Block Diagram			
PROJECT:	**zulu_a7**	REV:	9/2/2026 1:29:21 PM
AUTHOR:	Christian Tambe		Sheet: **1**

Power Supplies			
PROJECT:	zulu_a7	REV:	9/2/2026 1:29:21 PM
AUTHOR:	Christian Tambe		Sheet: 2

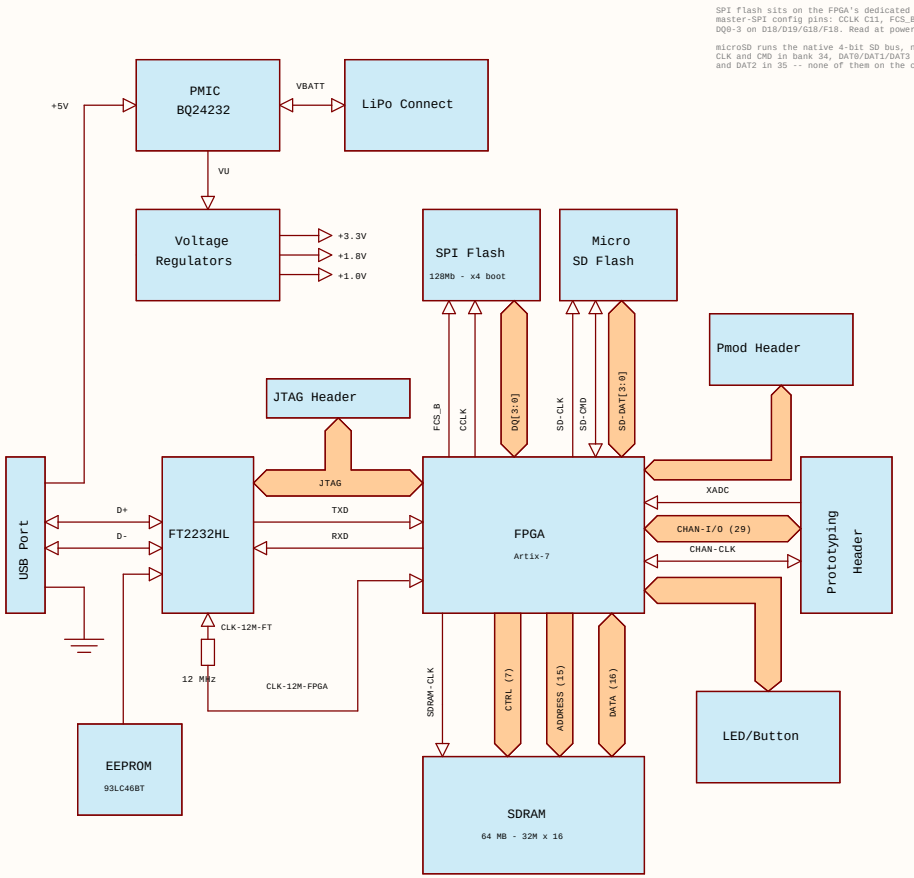
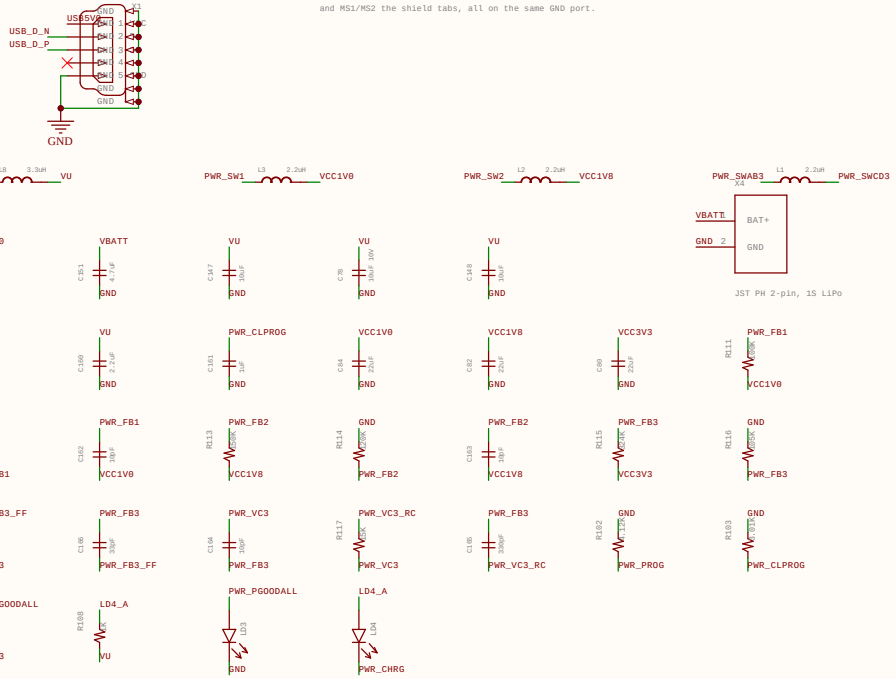
2026-09-10: X1 pin 5 owned nine pads ("5,MH1,MH2,MP1,MP2,MP3,MP4,MS1,MS2"), an EAGLE multi-pad import artefact that matches no Altium footprint pad. Now one pin per pad: 5 is USB GND, MH1/MH2 the mounting holes, MP1-MP4 the shell posts and MS1/MS2 the shield tabs, all on the same GND port.

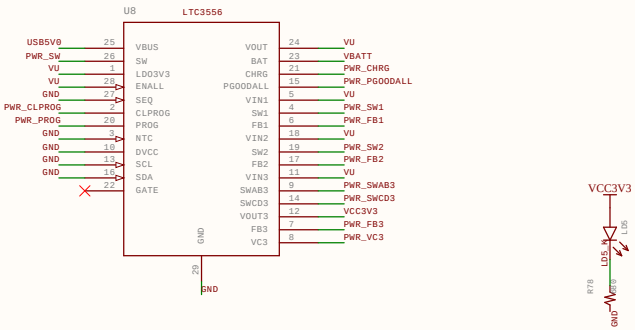
2026-11-10: U8 bq24232 + U5 TPS63802 + U6/U7 SC189 -> one Analog Devices LTC3556 (USB PowerPath, charger 248 mA, Buck1 VCC1V0 400 mA, Buck2 VCC1V8 400 mA, buck-boost VCC3V3 1 A). SEQ = GND starts 1V0 -> 1V8 -> 3V3 on ENALL; I2C off (DVCC/SCL/SDA = GND), so the USB input limit is the 1x mode set by R103 (3.01k placeholder, ~96 mA, value TBD). NTC grounded (pack has its own protection), GATE open (no external ideal-diode FET). LD3 = all rails good, LD4 = charging.

Memory			
PROJECT: zulu_a7		REV:	9/2/2026 1:29:21 PM
AUTHOR: Christian Tambe			Sheet: 4

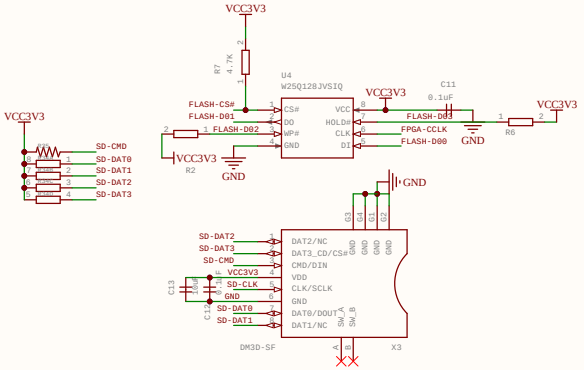
U3 = AS4C32M16SB-7TCN: 512Mbit (32M x 16) = 64MB. Pin-for-pin and dimensionally identical to the 256Mb AS4C16M16SA-6TIN it replaces -- all 54 pins and every TSOP-II dimension checked against both datasheets, and pin 40 is NC on both.
ONE DIFFERENCE, AND IT IS NOT A PIN: the column address is A0-A9 (1024 columns), not A0-A8 (512). The memory controller must be set to 10 column bits, or it reaches only half the array. Row A0-A12, banks BA0/BA1 and refresh (8192 cycles / 64ms) are unchanged.
-7TCN since 2026-09-08 (-6TIN dry): 143 MHz max at CL3, tRCD/tRP 21, tRC 63 ns, TA 0-70 C, IDD1 max 110 mA.

microSD runs the NATIVE 4-BIT SD BUS, not SPI. CLK, CMD and DAT0-DAT3 -- six signals, all in bank 34 byte group T0 (R2 T1 T2 U1 V2 W2), so they can be constrained as one bus. DAT1/DAT2 came from prototyping-header CHAN1/CHAN0; DAT3 is the old SPI chip-select, which needs no new pin. R34/R35 are the 4.7k pull-ups the SD spec requires on CMD and DAT0-DAT3. R9 (100R on DAT0 only) was removed: one damped line out of four is a skew, not termination.

2026-09-06: X3 is now the Hirose DM3D-SF push-pull socket (HRS 609-0025-8), DM3 catalog p9. Same 8-contact pinout; shell pads G1-G4 to GND; card-detect switch A/B (closed with card) left open. Needs its own footprint on the PCB.

FPGA Connections			
PROJECT:	zulu_a7	REV:	9/2/2026 1:20:21 PM
AUTHOR:	Christian Tambe		Sheet: 6

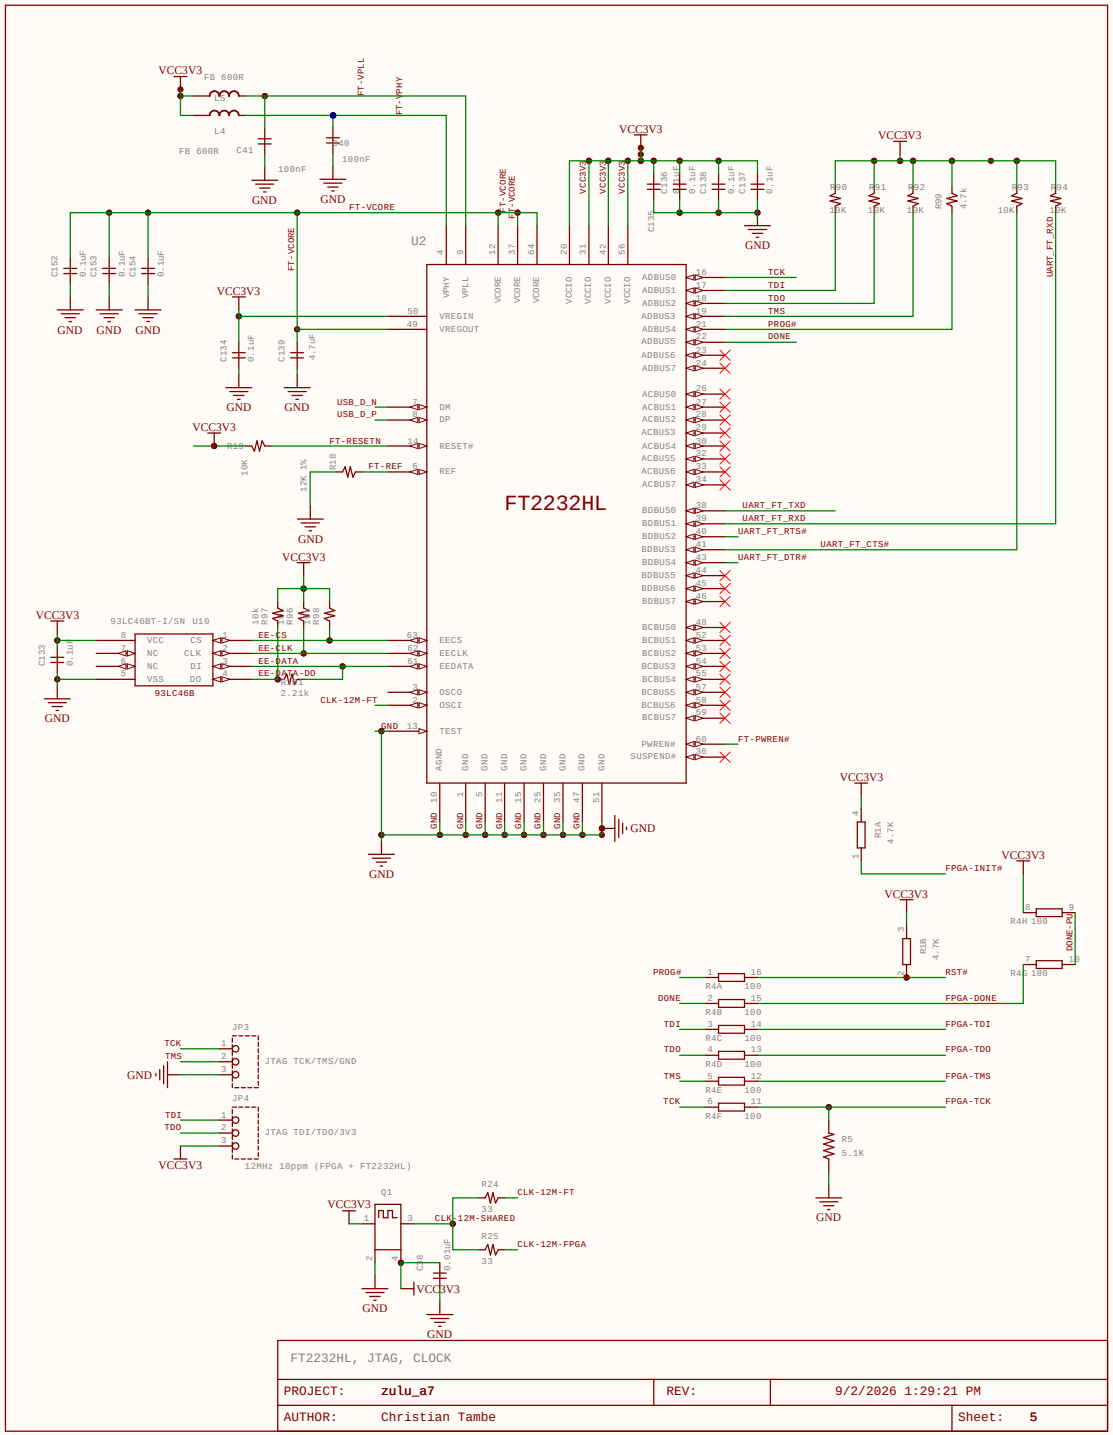
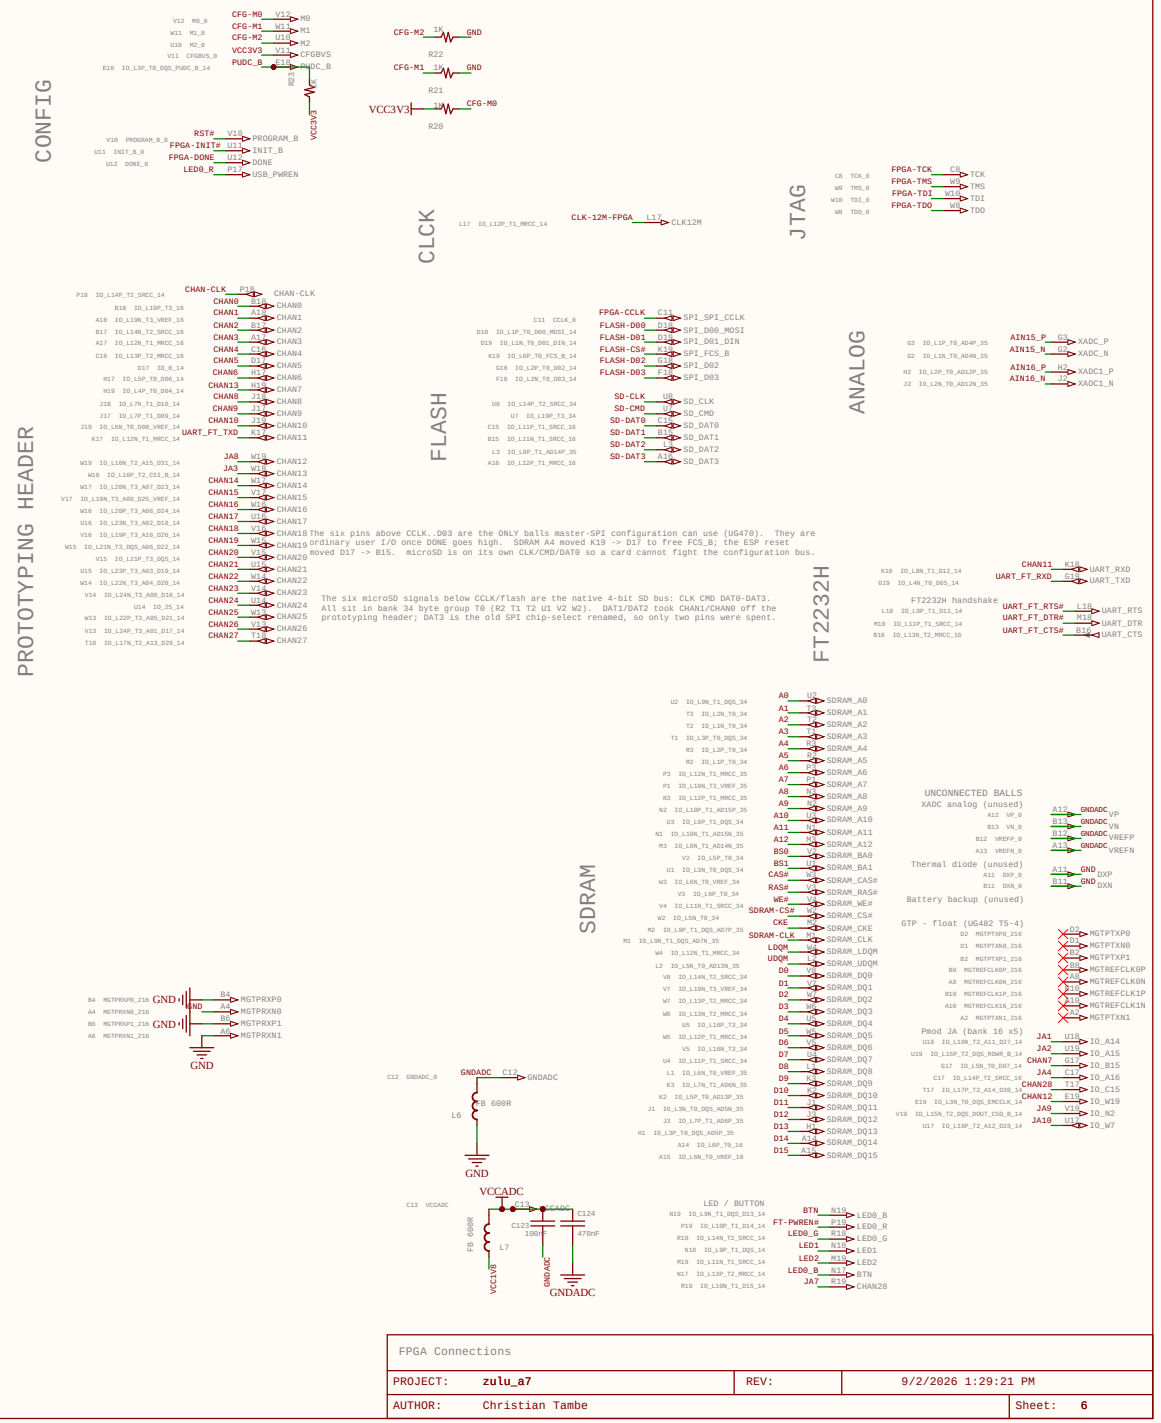
The six pins above CCLK..D03 are the ONLY balls master-SPI configuration can use (UG470). They are ordinary user I/O once DONE goes high. SDRAM A4 moved K19 -> D17 to free FCS_B; the ESP reset moved D17 -> B15. microSD is on its own CLK/CMD/DAT0 so a card cannot fight the configuration bus.

The six microSD signals below CCLK/flash are the native 4-bit SD bus: CLK CMD DAT0-DAT3. All sit in bank 34 byte group T0 (R2 T1 T2 U1 V2 W2). DAT1/DAT2 took CHAN1/CHAN0 off the prototyping header; DAT3 is the old SPI chip-select renamed, so only two pins were spent.
